UNITED STATES PATENT AND TRADEMARK OFFICE

10/527,162

Morten Sagstuen

DETAILED ACTION

FIG. 1.

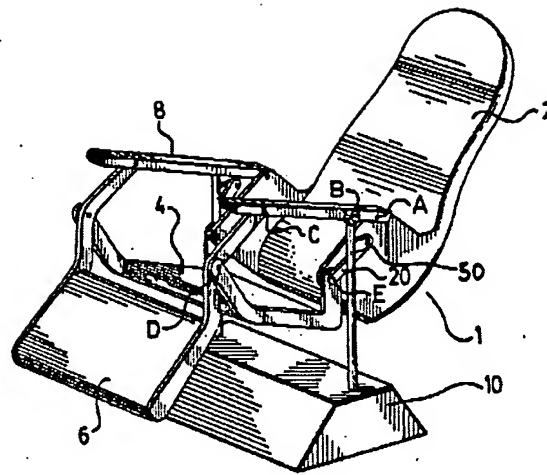
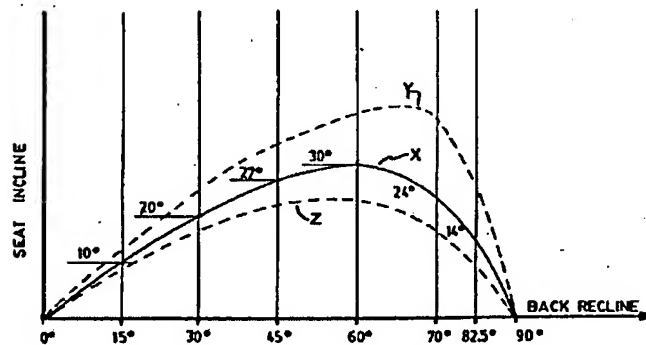
17. In re Claim 1, with reference to Figures 1 and 7, Henke discloses an adjustable chair (1) arrangement, in particular for a wheelchair (col. 2, line 38), comprising a seat (4) and a back (2) that are pivotally supported in two side members (8 and 11; figures 3 and 4) and are kinematically interconnected in such manner that an angle between the seat (4) and the back (2) will increase when the back (2) is swiveled backwards about its pivotal support (A and E) in the side members (8 and 11; col. 3, lines 45-49), which kinematic connection comprises a link (20) connection between the seat (4) and the back (2), characterized in that the link connection (20) is in the form of a link arm (20) arranged under the respective pivot supports of the seat (B) and the back (2) so that the distance between the back pivot support (A) and the back link arm connection (50) is less than the distance between the seat pivot support (B) and the seat link arm connection (E), and that the axis of rotation of the seat through the seat's pivot support (B) in the side members (8) passes essentially through or close to the user's centre of gravity (col. 3, lines 12-16, 31-34).

FIG. 5.

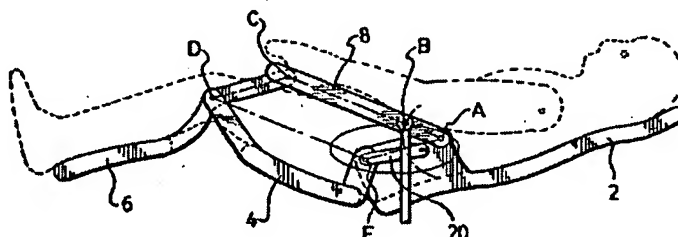
19. The examiner does not consider the recitation of the "user's hips" to limit the claim to a specific location. Henke, with reference to Figure 5, discloses pivot (A), which inherently passes through the upper portions of the hip and is the pivot support

for the back (2) of the chair (1). This is considered to be equivalent language to the applicant's "through the user's hip".
